**TIOGA COUNTY DEPT OF ECONOMIC DEVELOPMENT & PLANNING**  
**STAFF ANALYSIS AND RECOMMENDATIONS**  
**SECTION 239 REVIEW**

**COUNTY CASE:** #2021-022

**APPLICANT:** Ithaca Neighborhood Housing Services (INHS)

**REQUEST:** Site Plan Review, Floodplain Special Use Permit, Area Variances

**SHEET TITLE**  
 LAYOUT PLAN

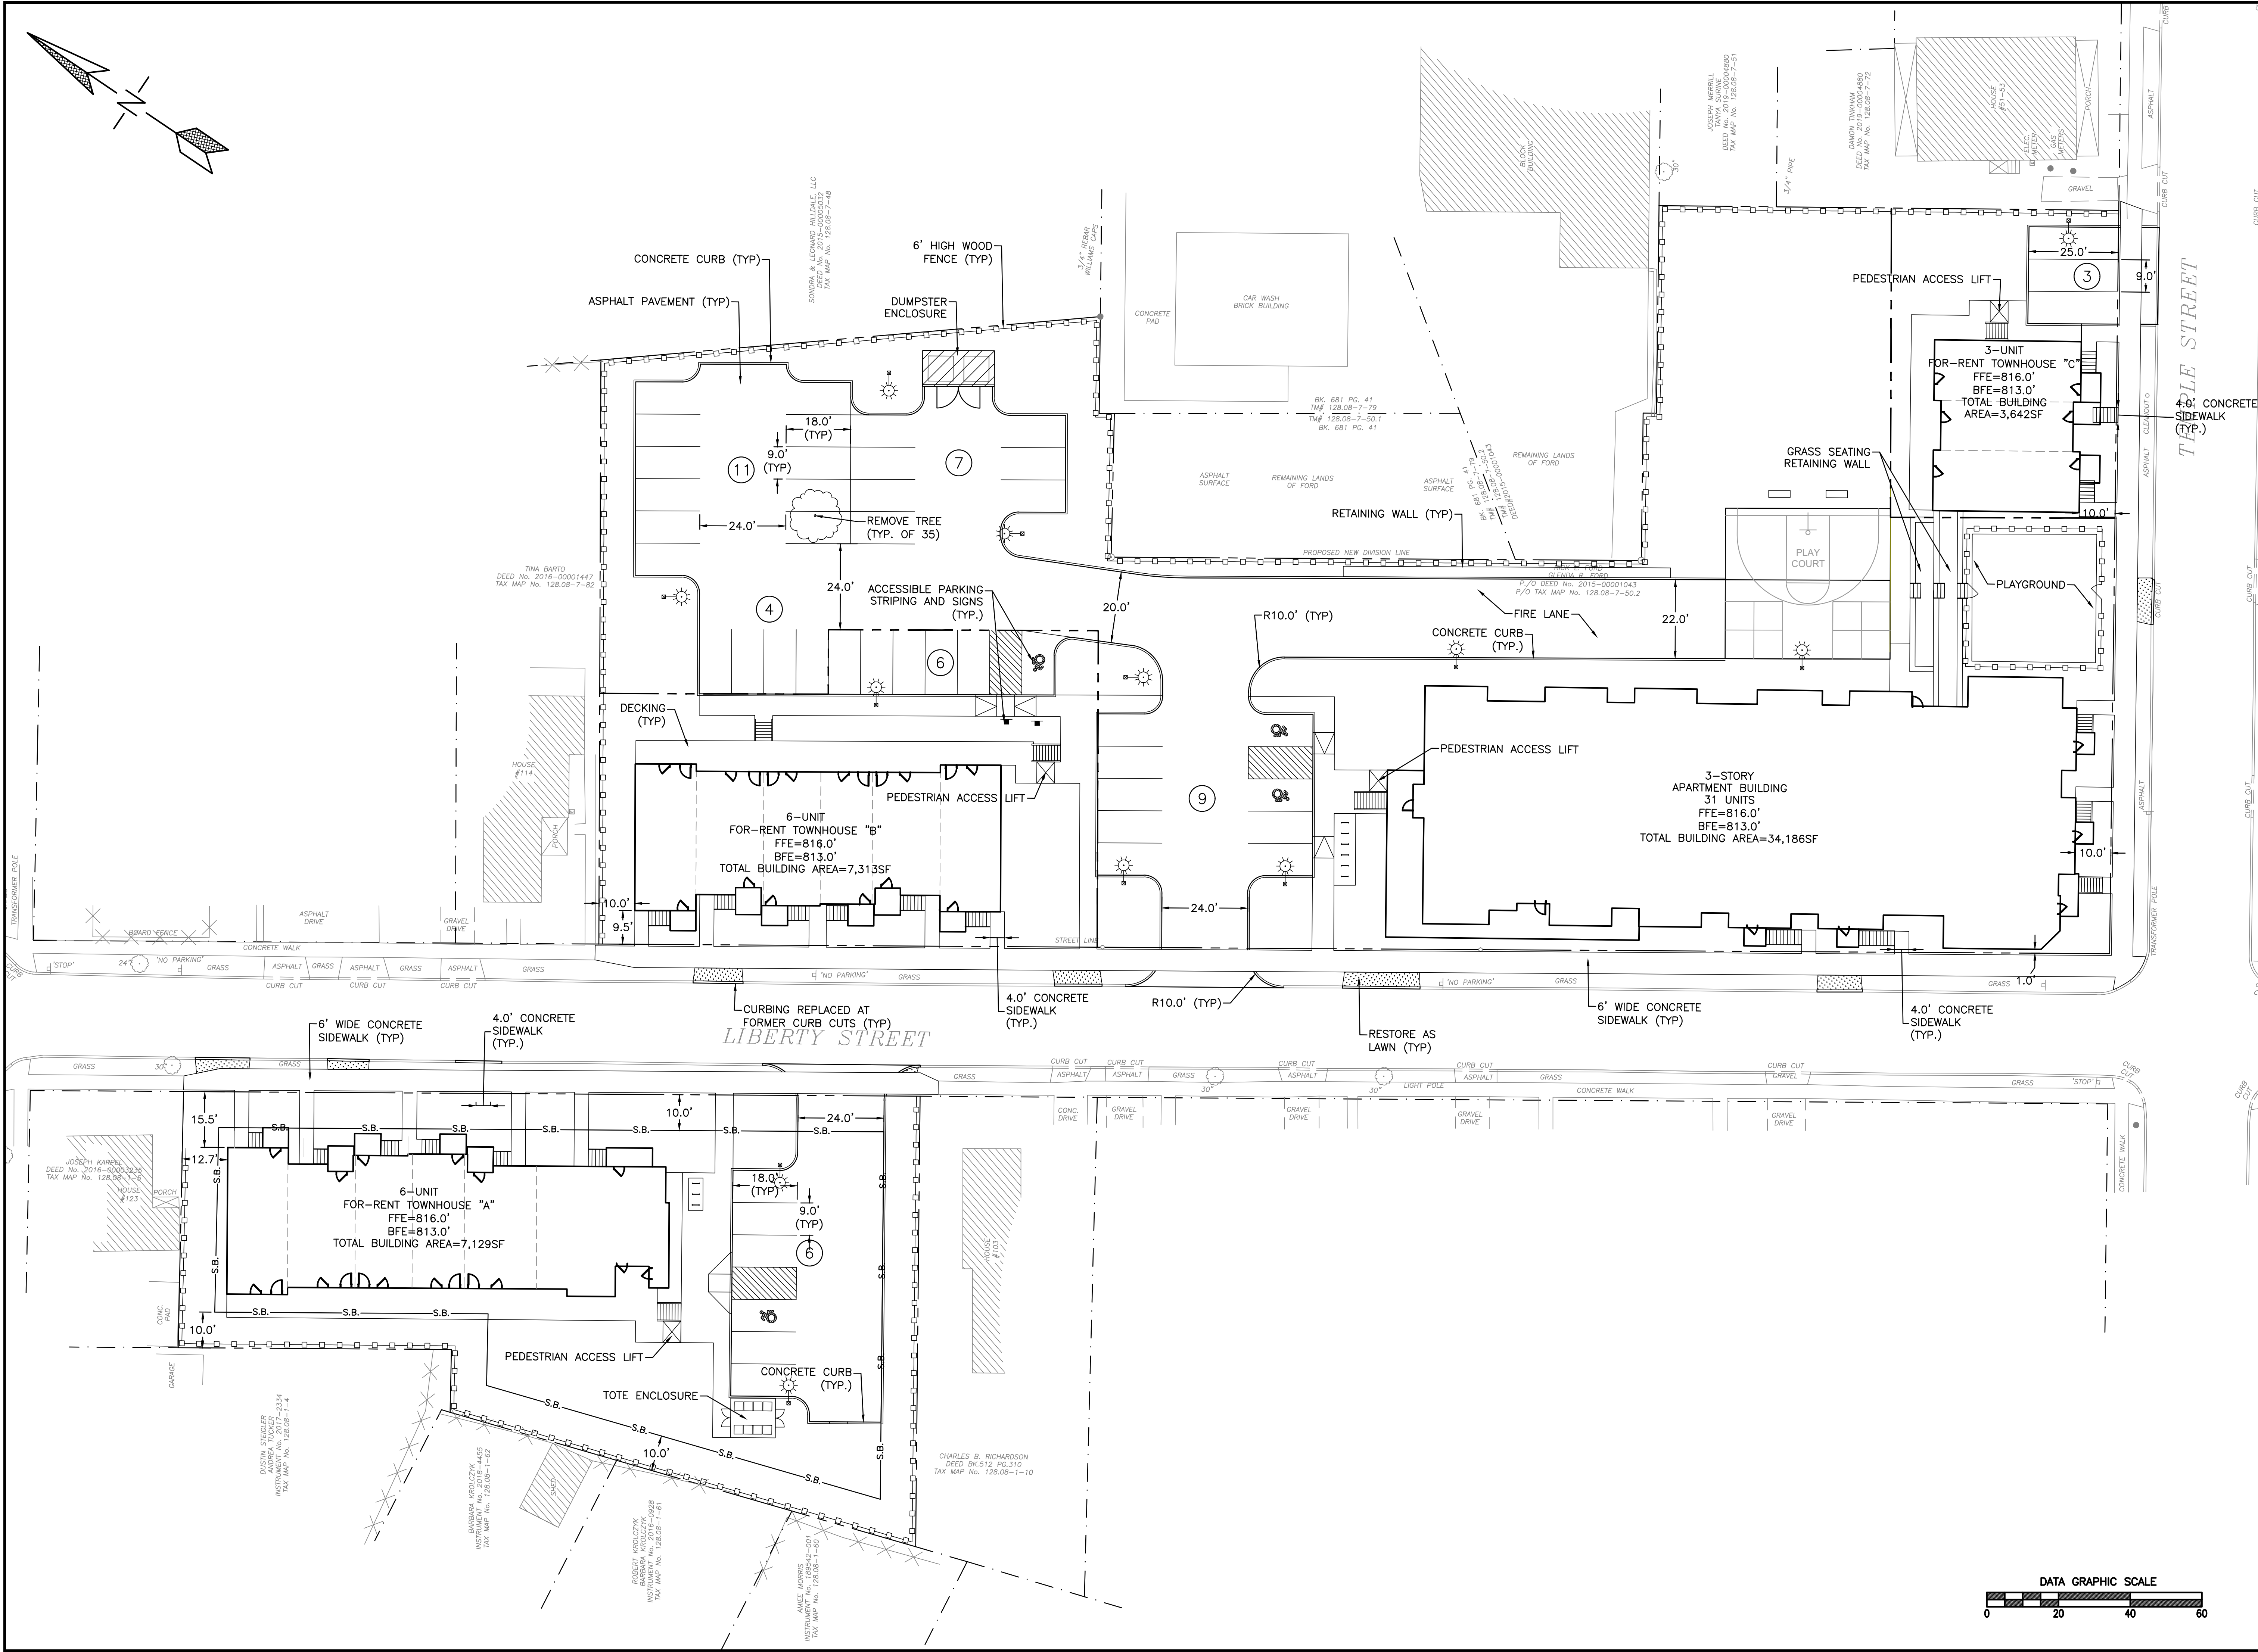
⇒ *The applicant's site plan shows buildings' frontage within the HD/MU zoning district to be in line with other buildings on the street and not at the front lot line, which is not closer to the street so an area variance is needed.*

- A. Surface parking shall be in the rear of the building.
  - ⇒ *The site plan shows nine parking spaces located at the left (north) side of the main apartment building and three parking spaces to the right (east) side of the three-unit townhouse structure. The Village ZBA must grant an area variance to allow these 12 spaces to be located on the side of the building, not in the rear.*
- B. Private parking ratios. (These requirements may be met on the site, or on other sites by evidencing appropriate documentation of agreements.)
  - (1) Residential uses: minimum one space per 1,000 square feet of gross floor area (or one per unit, whichever is less) and a maximum of two spaces per 1,000 square feet of gross floor area (or three per unit, whichever is less)
  - ⇒ *The applicant's proposal meets these parking space number requirements.*

- ⇒ *The applicant's site plan shows a logical and orderly layout of the buildings and parking lots related to the streets and within the properties, complete with landscaped buffer spaces and sidewalks, providing for safe pedestrian and traffic flow.*

SHEET TITLE  
**EXHIBIT C  
 CONCEPTUAL  
 PARKING PLAN**

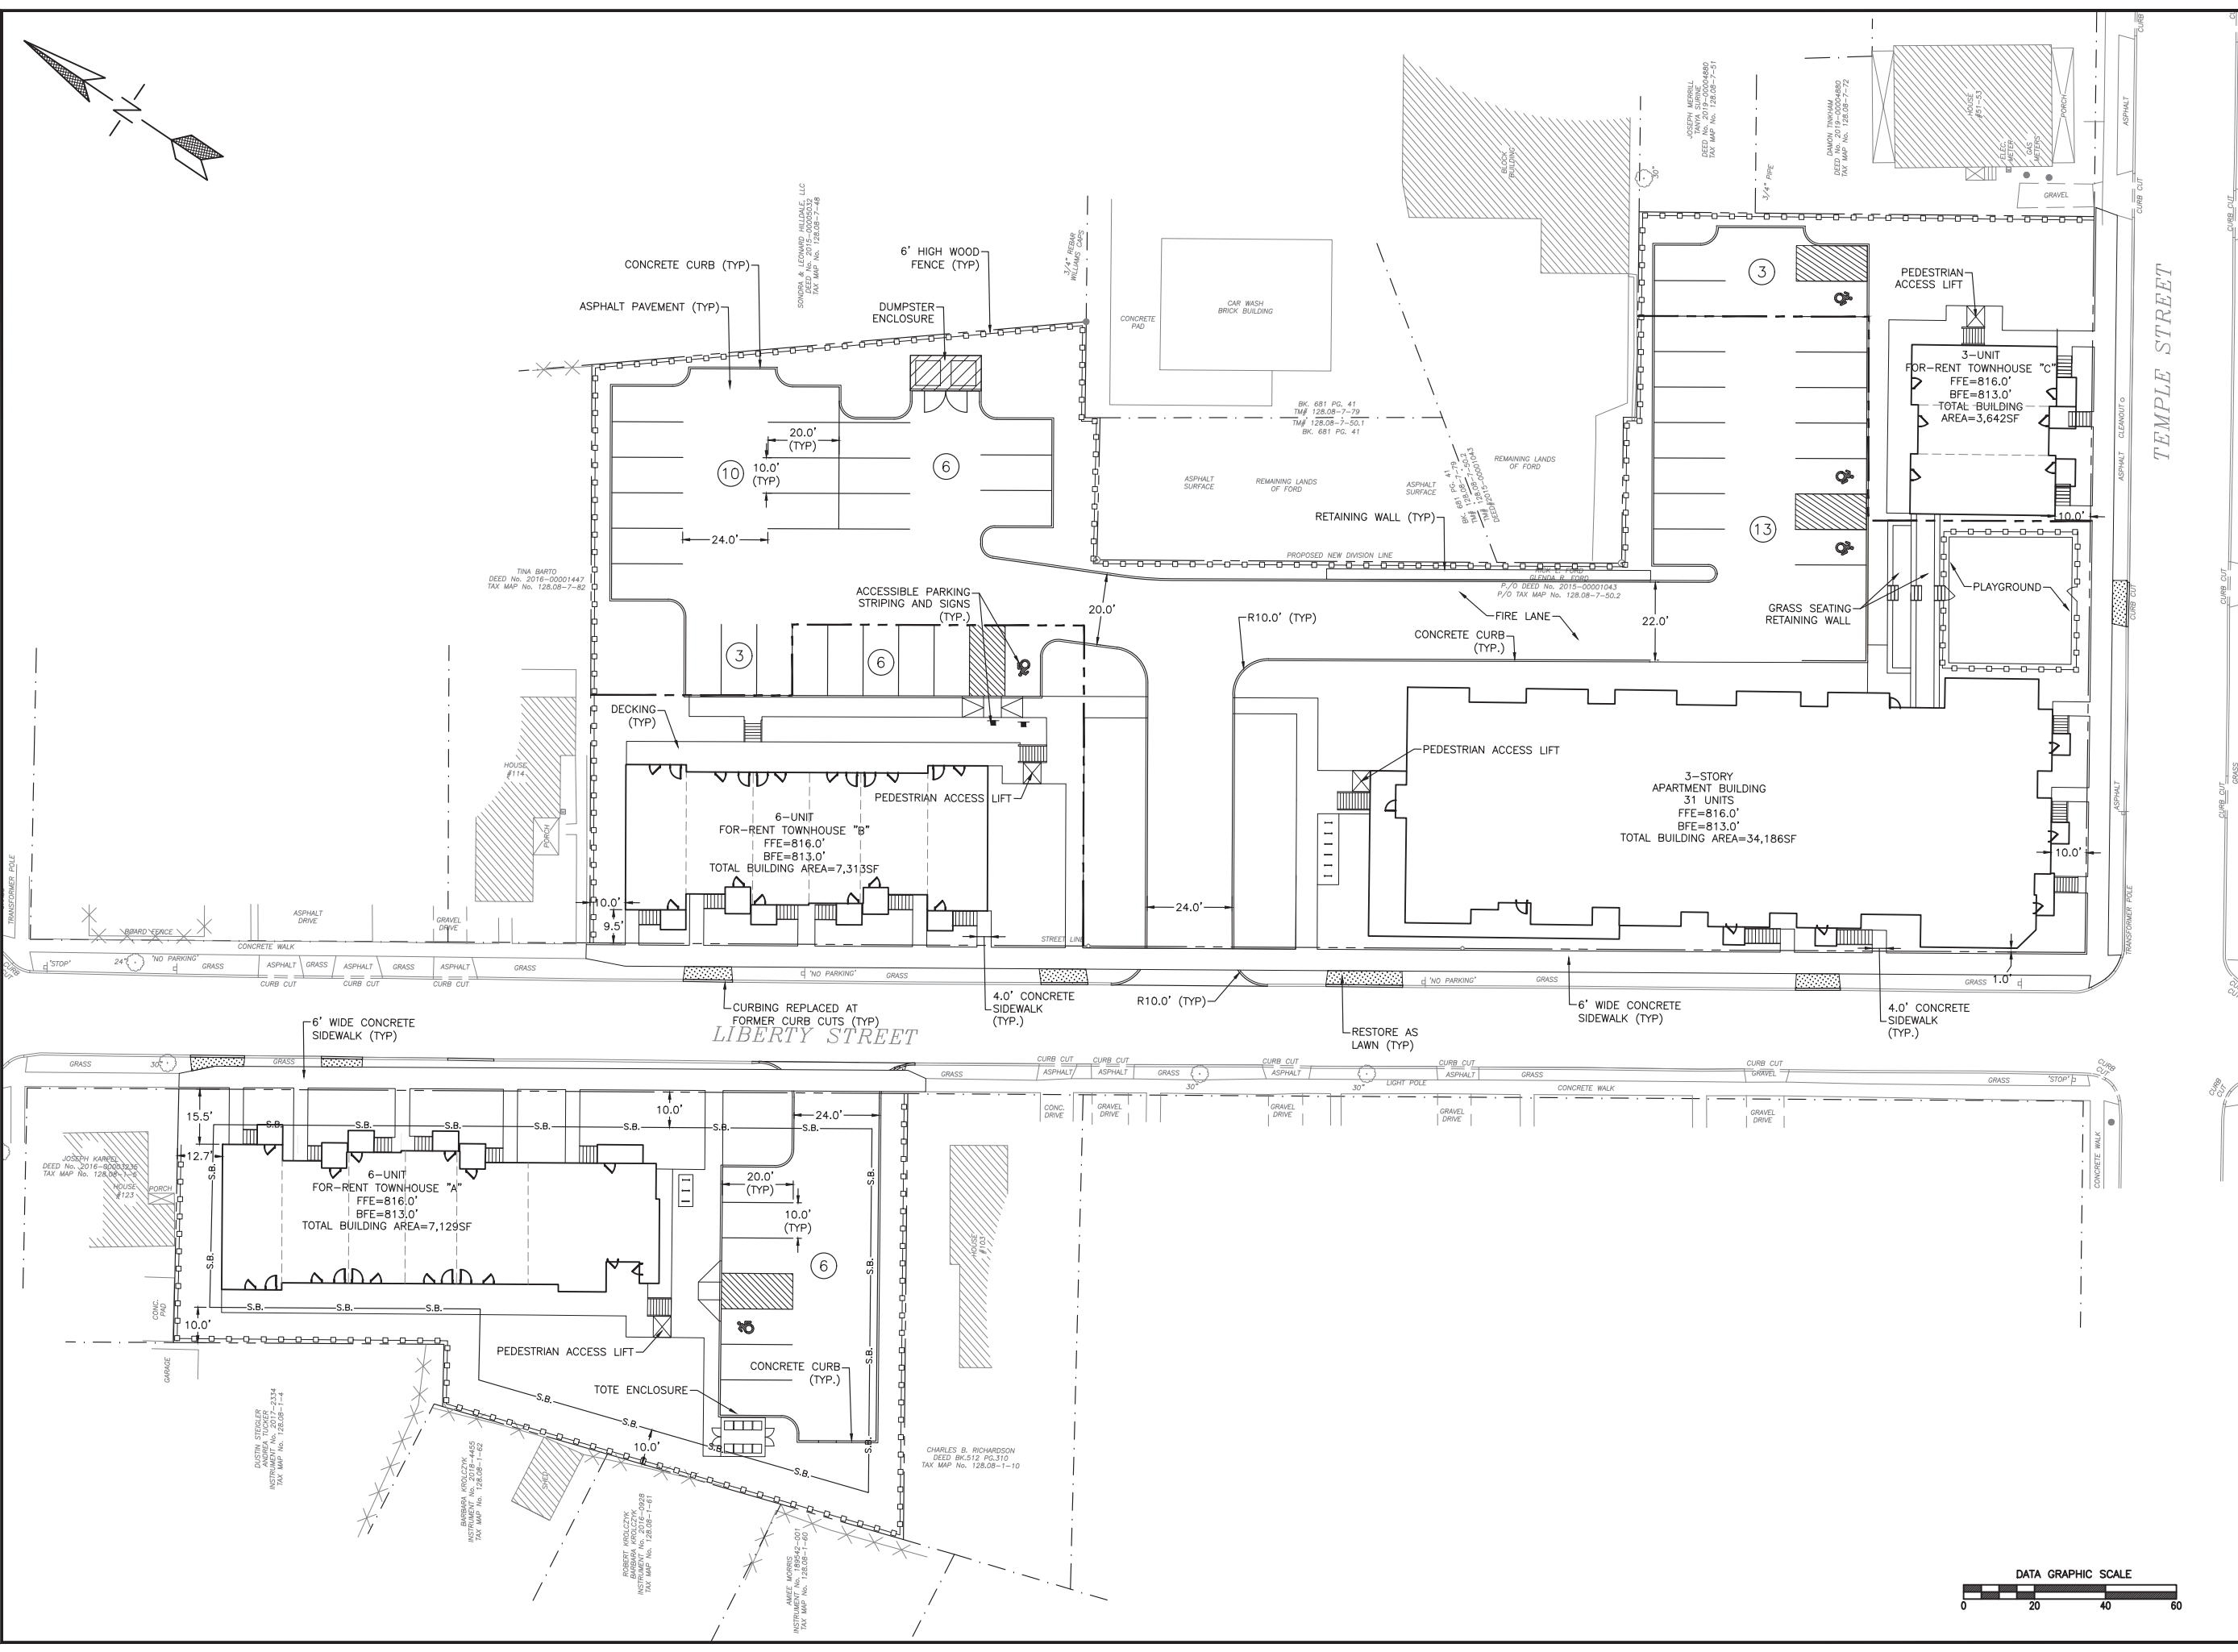
**Exhibit C:** Conceptual Parking Plan showing reduction in greenspace and increase in impervious without parking variances

This request relates to all four lots. Increasing the size of the parking spaces would require the parking to cover the majority of landscaped area on the project site. This would create additional impervious surface and add to the mitigation needed for stormwater run-off. Reducing the number of units would make the project financially
